**BEFORE THE
PUBLIC SERVICE COMMISSION OF ARKANSAS**

**In the Matter of Southwestern Electric)
Power Company's Petition for a)
Declaratory Order Finding that)
Installation of Environmental Controls)
at the Flint Creek Power Plant Is in the)
Public Interest)**

Docket No. 12-008-U

**DIRECT TESTIMONY OF
PAUL CHERNICK
ON BEHALF OF
THE SIERRA CLUB**

1 **Figure 1: Henry Hub Prices, SWEPCo Forecasts and Forwards over Time**

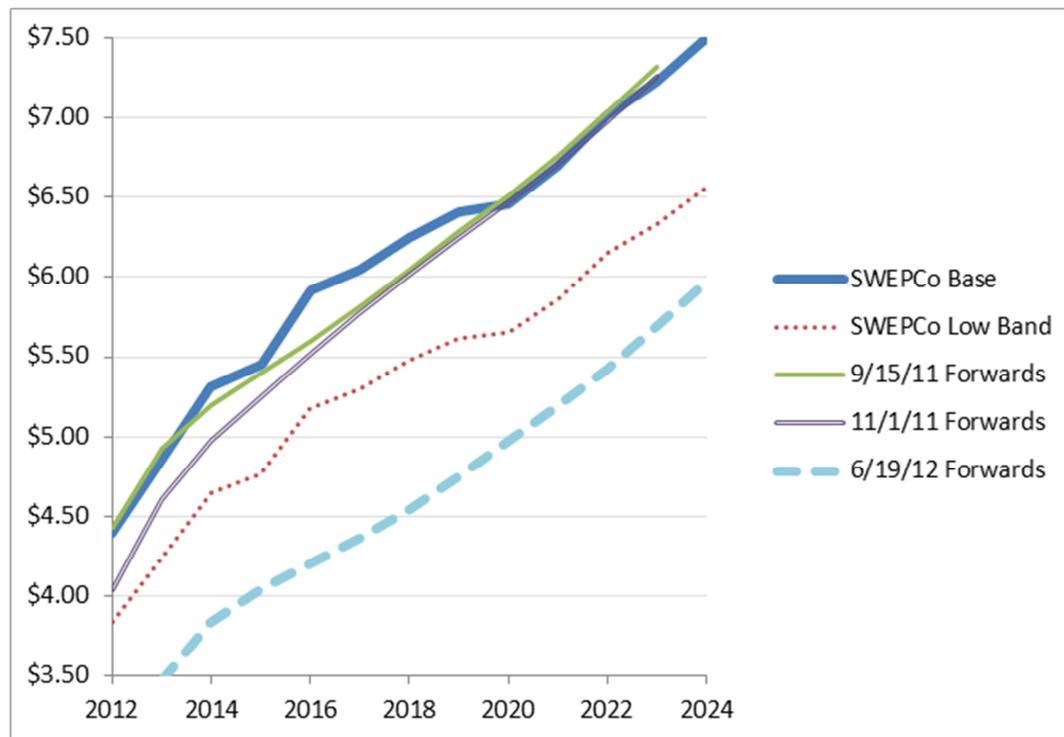
3 Figure 1 shows the Company’s base forecast for natural gas at Henry Hub
4 (the “Fleet Transition–CSAPR” case) and its lowest Henry Hub forecast (the
5 “Fleet Transition–CSAPR: Lower Band” case), along with Henry Hub forwards
6 from September 2011, November 2011 and June 19 2012.

3 Figure 1 shows that SWEPCo’s base case was very similar to the forwards
4 prices from September and November. Current forwards are not just lower than
5 SWEPCo’s base case, but also lower than the Company’s low-band forecast.
6 Indeed, the current natural-gas forwards average about as far below SWEPCo’s
7 low-band case as its low-band case is below the Company’s base forecast.
